TOLEDO - LUCAS COUNTY PLAN COMMISSIONS

REF: SUP-5005-23

SUBJECT: Special Use Permit for used auto sales at 3125 Dorr Street

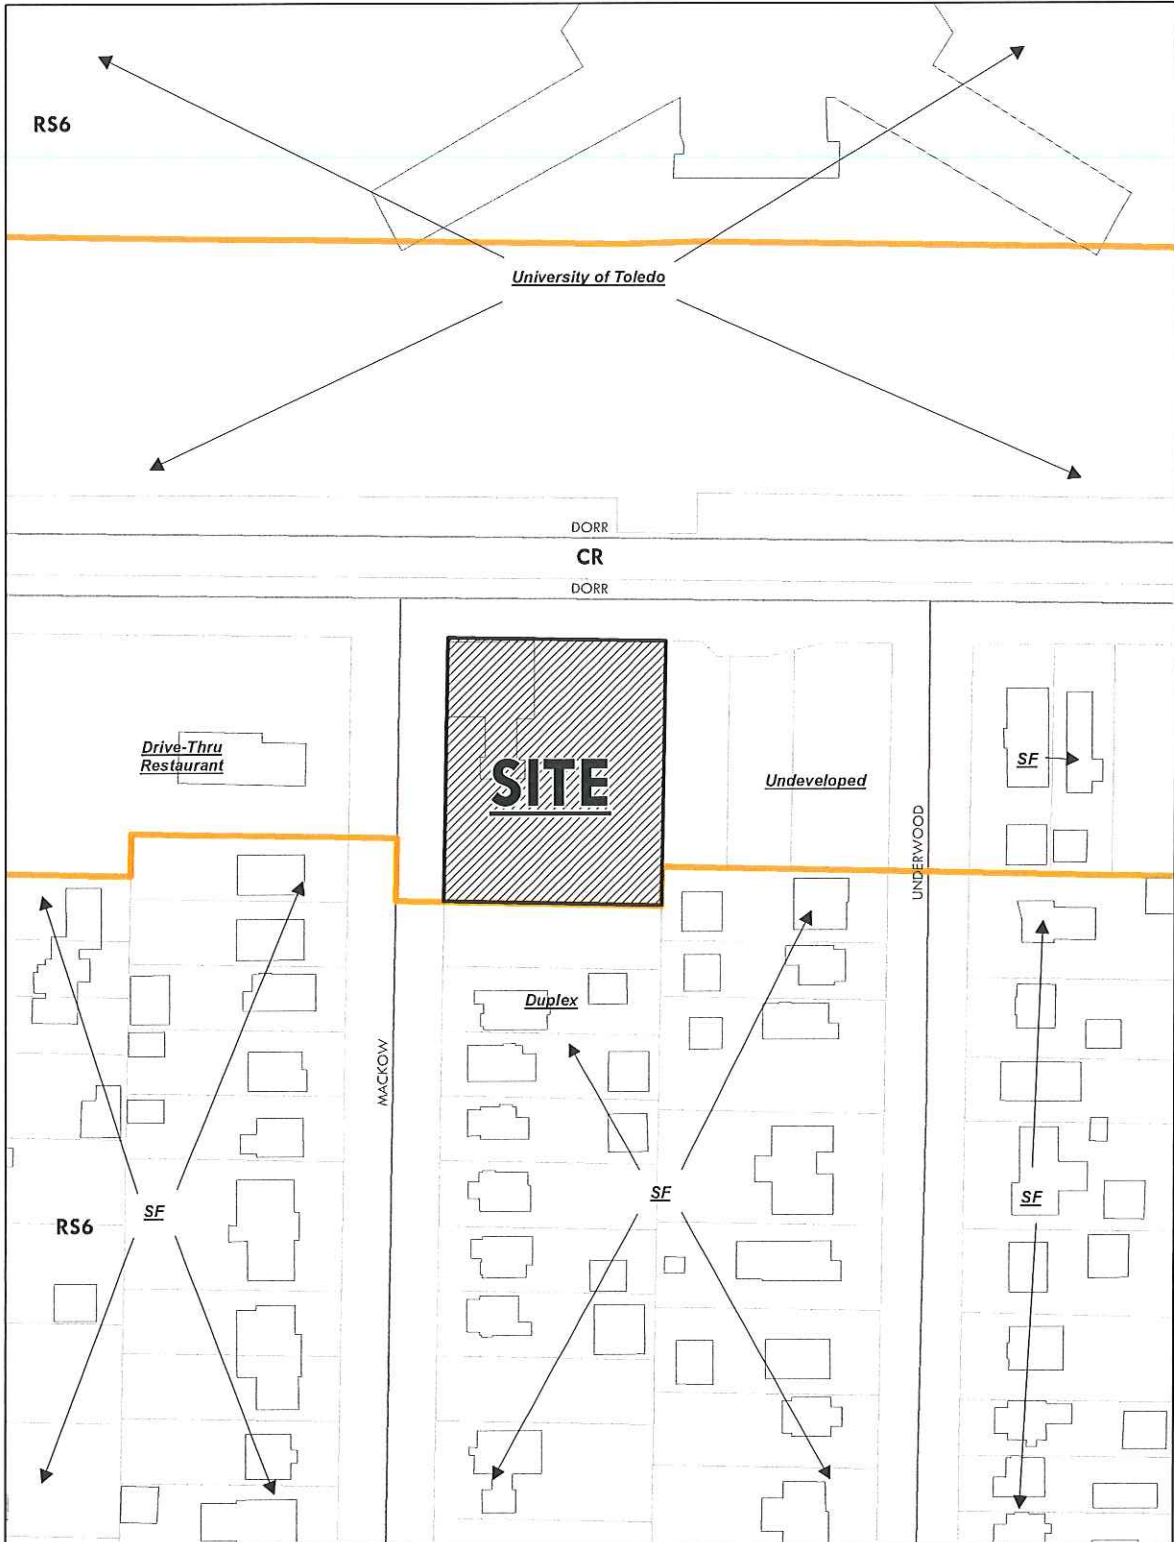
Used auto sales require fencing around customer display areas, and screening for any outdoor storage (**TMC§1104.0305**). The site plan depicts a decorative metal fence along Dorr Street and twenty feet (20') from Dorr Street going south along the east property line. A chain link fence with privacy slats is proposed from where the decorative fence ends to the southern property line. Per TMC§1108.0404(B), chain link cannot be used to meet buffer and screening requirements. A revised plan depicting an acceptable material shall be provided.

Frontage greenbelts as outlined in **TMC§1108.0202** are required along Dorr Street and along Mackow Drive. Six (6) trees along Dorr Street are provided, which meet the requirement of one (1) tree per thirty feet (30') of frontage. No trees are proposed along Mackow Drive. A minimum of four (4) trees shall be provided in the tree lawn as there are existing street trees lining Mackow Drive. Applicant shall contact the Division of Forestry to request the street trees and a revised site plan shall be provided.

As the CR-Regional Commercial site abuts RS6-Single Family Residential to the south, a Type A landscape buffer shall be installed along the eastern property line per **TMC§1108.0203**. The site plan depicted a new board-on-board fence that is 3'6" tall in the front setback and 6' tall along the rest of the property. Four (4) trees and fifteen (15) shrubs are shown abutting the fence. As the site is 136' in width, one (1) additional tree and six (6) shrubs are required in order to meet the Type A Landscaping requirement.

Well maintained parking lot landscaping is tremendously important for auto sales businesses with outdoor display areas. **TMC§1108.0204** outlines the requirements for both interior and perimeter parking lot landscaping. The interior of the parking lot requires two (2) trees and six (6) shrubs per each ten (10) parking spaces. The total number of parking spaces, including the display area, is twenty-three (23), requiring five (5) trees and fourteen (14) shrubs. Six (6) trees and eleven (11) shrubs are provided. Per **TMC§1108.0204(C)(1)(b)**, One (1) canopy tree may substitute for three (3) shrubs. The applicant is proposing summer red maples, and therefore the site plan meets the interior requirements. Perimeter landscaping requires a continuous shrub row and one (1) tree per thirty linear feet (30'). The east side of the parking lot has a shrub row with five (5) trees and is compliant. The west side however has a shrub row with no trees. A revised site plan with at least three (3) trees on the west side of the parking lot shall be provided.

5. A site plan error is noted. The existing storm drain on the site plan does not exist.
6. It is unclear from the Plan Commission submittal if the proposed work will entail earth-disturbing activity of 2,500 or more square feet, or if there will be any changes to the existing storm sewer system. If revisions are made to the site plan that will result in earth-disturbing activity of 2,500 or more square feet or cause changes to the existing storm sewer, a full site plan review and approval will be required by the Division of Engineering Services. Plans will be subject to the rules and regulations of the City of Toledo, Stormwater Utility, including stormwater detention and post-construction stormwater BMPs as specified in the City of Toledo Infrastructure Design and Construction Requirements and the Ohio EPA NPDES General Stormwater Permit for Construction Activities.

- a. Used auto sales require decorative fencing around display areas. A chain link fence is proposed. **Not acceptable as depicted, per TMC§1108.0404(B), chain link cannot be used to meet buffer and screening requirements. Revised plan with an appropriate fence material shall be provided.**

- b. A fifteen-foot (15') frontage greenbelt is required along Dorr Street and Mackow Drive frontages, and shall include one (1) tree per every thirty feet (30') of frontage; **not acceptable as depicted, revised site plan with at least four (4) street trees along Mackow Drive shall be provided.**

- c. A Type A Landscape buffer shall be installed on the southern side of the property per where the site abuts RS6-Single Family Residential Zoning. Four (4) trees and fifteen (15) shrubs are shown abutting the fence. **Not acceptable as depicted. As the site is 136' in width, one (1) additional tree and six (6) shrubs are required in order to meet the Type A Landscaping requirement.**

- d. Perimeter landscaping shall be installed along any parking lot area adjacent to a street, place, or driveway and shall be provided abutting the parking area to visually screen all off-street loading facilities from view of public right-of-ways. A minimum of at least one canopy tree must be provided for each 30 linear feet, plus a continuous shrub with a minimum height of 18 inches. **Not acceptable as depicted. A revised site plan with at least three (3) trees on the west side of the parking lot shall be provided.**
